# Public Utility Commission of Texas

## Memorandum

**RE:** Docket No. 49879 – *Application of Swift Water Supply Corporation to Amend its Water Certificate of Convenience and Necessity in Nacogdoches County*

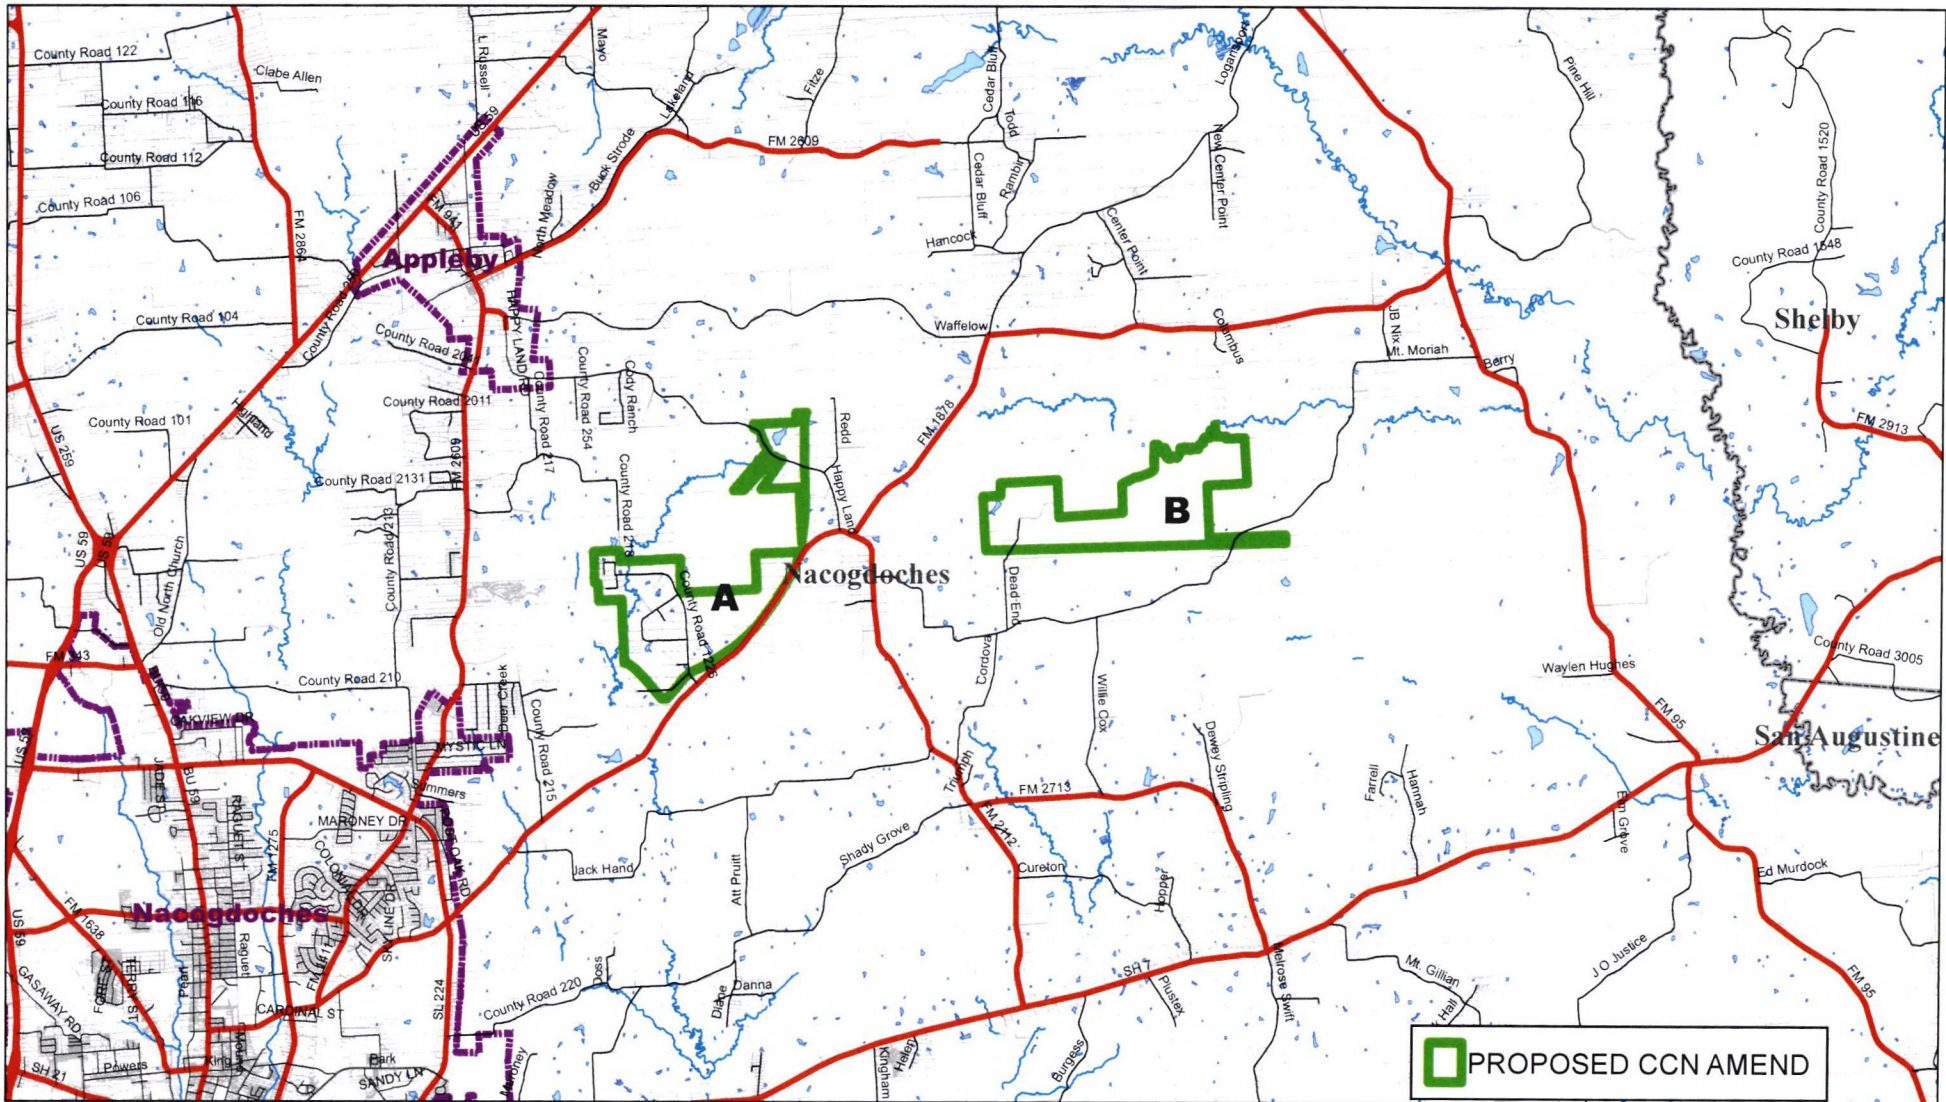
For Part B, Staff requests the following parcels be removed:

- 1) 13868
- 2) 7711
- 3) 7709
- 4) 7710
- 5) 10827
- 6) 13862
- 7) For parcel 10827, Staff suggests drawing a line straight down from the western border of 10827 straight down to the current CCN area.

- a. A revised detailed map identifying the requested area after removing the parcels of land identified above.
- b. Revised digital mapping data in a shapefile format georeferenced in either NAD 83 Texas State Plane Coordinate System (US Feet) or in NAD 83 Texas Statewide Mapping System (Meters) for the revised requested area, after removing each tract of land Staff has mentioned above.
  - The digital mapping data must include a single, continuous polygon record for the revised requested area; and
- c. The total acreage for the revised requested area after removing the tracts of land Staff identified above. The total acreage for the revised requested area must correspond to the total acreage included with the digital mapping data included above in part b. 1,968.72 Acres
